Kōrero mai | Let's talk

Wyon / Hulbert Street renewal feedback

Option 2 — narrow to 6-metre road width

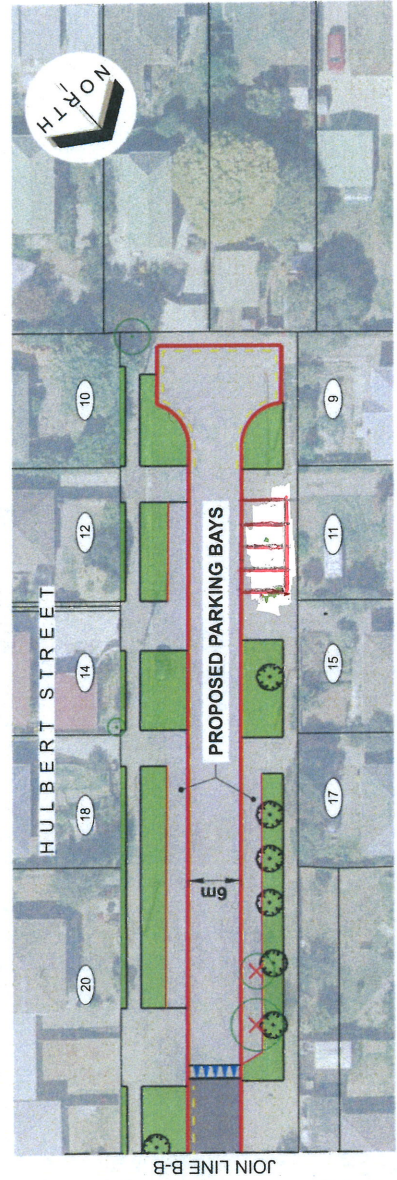
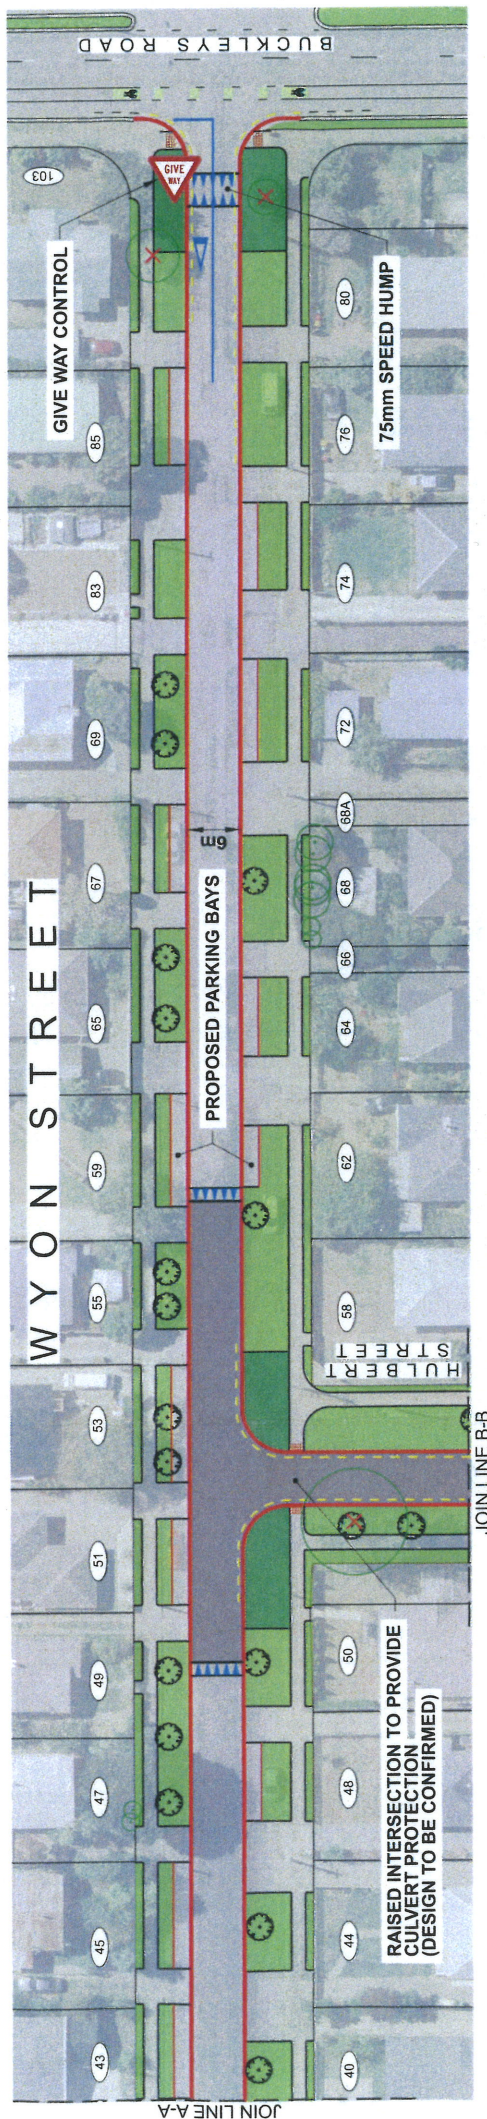
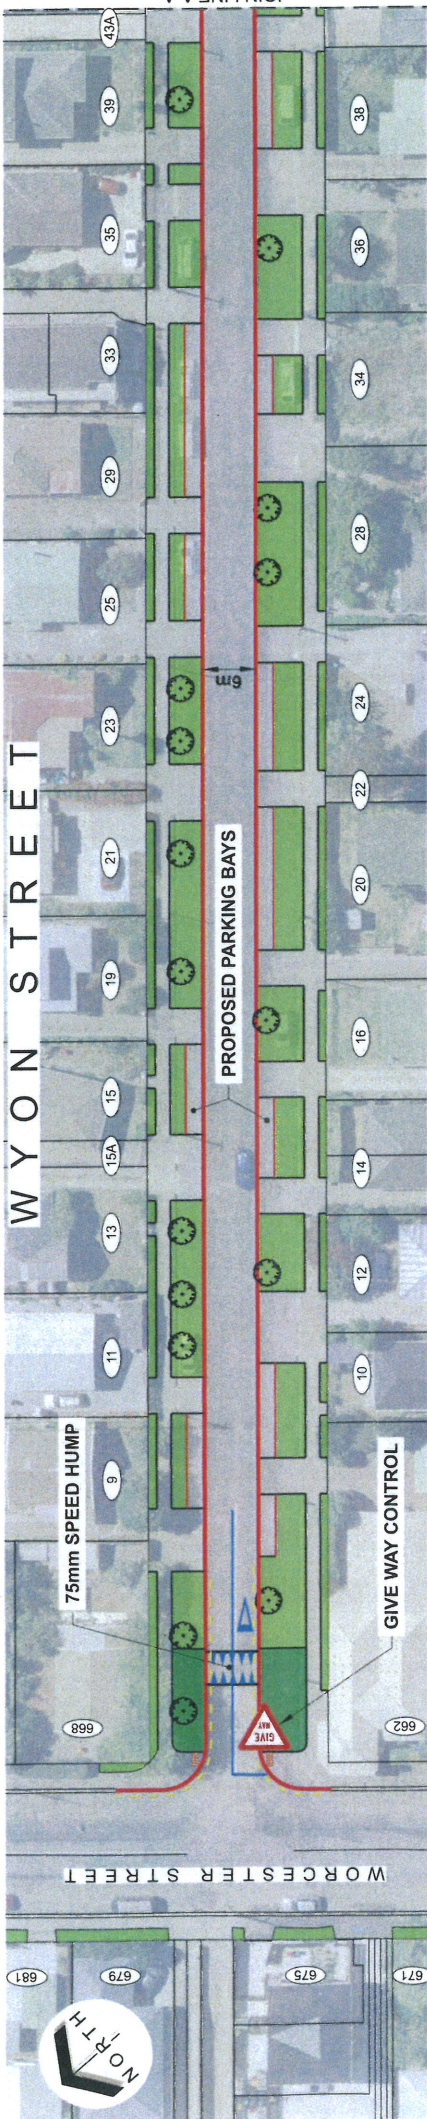
Long Text
It was exciting to receive the flyer on the proposed improvements to Wyon and Hulbert Street. I am the owner/developer of 11 Hulbert Street. We completed the development to remove the old, dilapidated property and provide 5 new townhouses at the property.
Having reviewed the 2 options I feel Option 2 provides the best solution as this retains some street parking which I think will be useful and prevent any disruption. I do have a couple of questions and a request for consideration. Most properties are single dwellings or, where multi units, have off-street parking for at least 2 vehicles. 11 Hulbert is a 5-townhouse development which does have a single parking space for each property. At present the properties are rented and generally are one vehicle households. However, to future proof, where 2 car household could be a possibility, could the option to provide street parking bays be allowed for, as per the attached plan. From the scale it would seem like this is possible but would need to be confirmed.

It would also seem from the options that the new footpath will be directly on the boundary of each property. At present each property has a berm on the boundary, what is the intention to finish the existing street frontage. Also, if the pavements are being pulled back I assume the road crossovers will also be replaced?
